*RE:* Comments on the Draft Environmental Impact Report (EIR) Estrella Substation and Paso Robles Area Reinforcement Project – Submitted to Horizon Water and Environment via email on February 21, 2021(estrellaproject@horizonh2o.com)

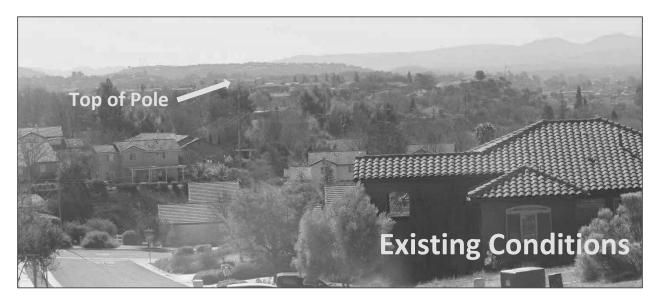
The photo below illustrates this point. The height of the existing poles and wires is low enough to largely blend in with the existing tree cover and the rolling topography. Adding 40 feet or more to the height of the poles and wires will make them far more exposed and visible from numerous vantage points around the community.

The EIR fails to adequately assess the negative aesthetic impacts of new poles in the reconductoring area that in some cases, will be 40 feet (or more) taller than existing poles. Furthermore, it does not consider alternatives that would relocate the existing 70kv lines outside of all or part of the existing residential neighborhoods.
